DCUSA Change Proposal (DCP)		At what stage is this document in the process?
<h1>DCP 283</h1> <p><b>DCP Title: The calculation of generation credits in the CDCM</b></p> <p>Date Raised: 12 October 2016</p> <p>Proposers Name: Johannes Nowak</p> <p>Company Name: MVV Environment Services Limited</p> <p>Company Category: Supplier</p>		<p><b>01 – Change Proposal</b></p> <p>02 – Consultation</p> <p>03 – Change Report</p> <p>04 – Change Declaration</p>
<p><b>Purpose of Change Proposal:</b></p> <p>The intent of this change proposal is to amend the calculation of credits for embedded generation to more closely reflect the benefits they bring to Distribution Network Operators.</p>		
	<p>Governance:</p> <p>The Proposer recommends that this Change Proposal should be:</p> <ul style="list-style-type: none"> <li>Part 1</li> <li>Treated as a Standard Change</li> <li>Proceed to Working Group</li> </ul> <p>The Panel will consider the proposer’s recommendation and determine the appropriate route.</p>

<p>Impacted Parties: <b>Distributors, Suppliers, Distributed Generation</b></p>	
	<p>Impacted Clauses: <b>Schedule 16 (CDCM)</b></p>

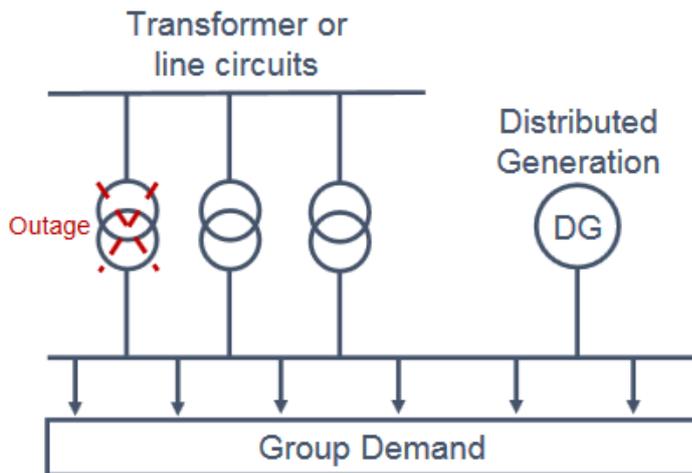
The basic principle of P2/6 and ETR130 is that embedded generation can offset the need for network capacity depending on the reliability of the generator and its setup. A simple example where an embedded generator offsets the need for a transformer is shown in the diagram below:

The more reliable the generator is the more the DNO can rely on it for network planning purposes. P2/6 sets out the reliability factors (labelled “f” factors) for different types of generation. Where a generator is intermittent, an additional persistence factor is also taken into account.

When assessing the ability of an embedded generator to offset network capacity, P2/6 refers to a demand group. The demand group is not specified as a network level and the assumption within the CDCM is that the benefit will be realised at the next voltage level up (eg for a LV circuit the benefit will be realised at the LVS transformer).
